1.1 Company		STMicroelectronics International N.V
1.2 PCI No.		ADG/20/12232
1.3 Title of PCI		Orientation of PowerFLATTM 8X8 HV Package in carrier tape & Datasheet update
1.4 Product Category		Power MOSFET
1.5 Issue date		2020-06-30

CUSTOMER NOTIFICATION
Orientation of PowerFLAT™ 8X8 HV Package in carrier tape
Datasheet update

NEW PowerFLAT™ 8X8 HV top right Package orientation in carrier tape

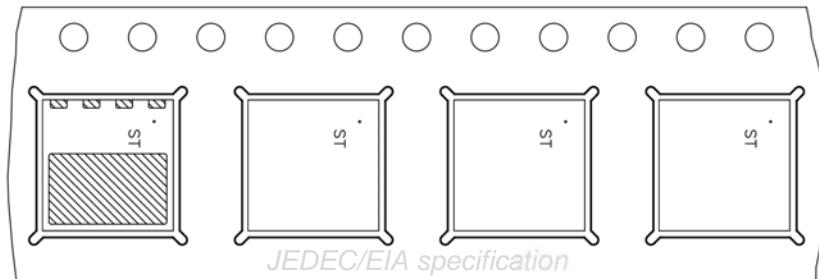
Purpose of the current notification is to inform you that we are going to update the PowerFLAT™ 8x8 HV package orientation in carrier tape. The change will be reported also into the relative datasheets.

This change has been done according to the JEDEC/EIA specification. The new package orientation in carrier tape will be as follows:
